Access Compliance Report

Public Rights-of-Way

Intersection ID: 24503	Main Street: BRUFF_CT	Cross Street: SAINTFIELD_PL	Location: SW
ADA ID: 977DFDA42194	Ramp Type: Perp	Initial Pass/Fail: Fail	Overall Compliance: No
Codes/Mitigation Info/Possible Solution		Field Measurements/Component Compliance	
Severity Score: 10

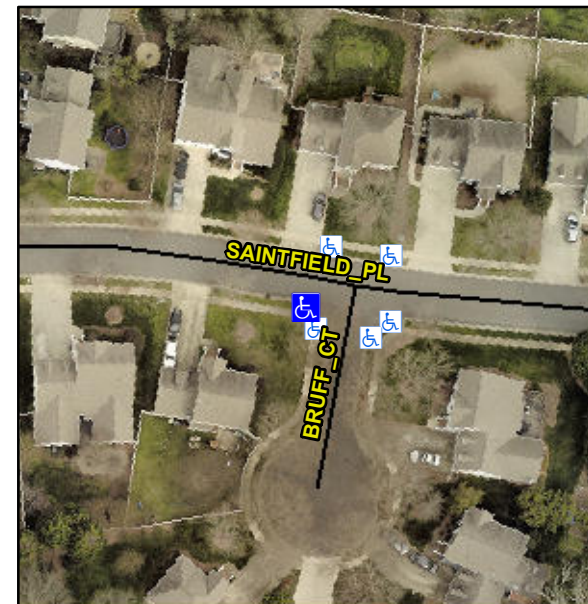
Not Found, R304.5.1, R304.5.3

Compliance	Description	Data	Compliance	Description	Data
N/A	Ramp Length (in)	46.0	Yes	Ramp Slope (%)	7.3
No	Ramp Width (in)	36.0	No	Ramp XSlope (%)	3.3
N/A	Flare Type LT	N/A	N/A	Flare Type RT	N/A
N/A	Flare Slope LT (%)	N/A	N/A	Flare Slope RT (%)	N/A
N/A	Flare Traversable LT?	N/A	N/A	Flare Traversable RT?	N/A
N/A	Landing Length (in)	N/A	N/A	DWS Provided?	N/A
N/A	Landing Width (in)	N/A	N/A	DWS Contrast?	N/A
N/A	Landing Slope (%)	N/A	N/A	DWS Length (in)	N/A
N/A	Landing X Slope (%)	N/A	N/A	DWS Full Width?	N/A
N/A	Landing Curb? (Y/N)	N/A	N/A	DWS Offset (in)	N/A
N/A	Shared Landing?	N/A			
N/A	Gutter Ponding?	N/A	N/A	Gutter Slope (%)	N/A
N/A	Gutter Lip Ht (in)	N/A	N/A	Gutter X Slope (%)	N/A
N/A	Painted X Walk1?	No	N/A	Painted X Walk2?	N/A
	X Walk 1 Direction	To N		X Walk 2 Direction	N/A
N/A	X Walk 1 Width (in)	N/A	N/A	X Walk 2 Width (in)	N/A
	X Walk 1 Slope (%)	0.6		X Walk 2 Slope (%)	N/A
	X Walk 1 X Slope (%)	2.4		X Walk 2 X Slope (%)	N/A

Remove & Replace Entire Ramp.
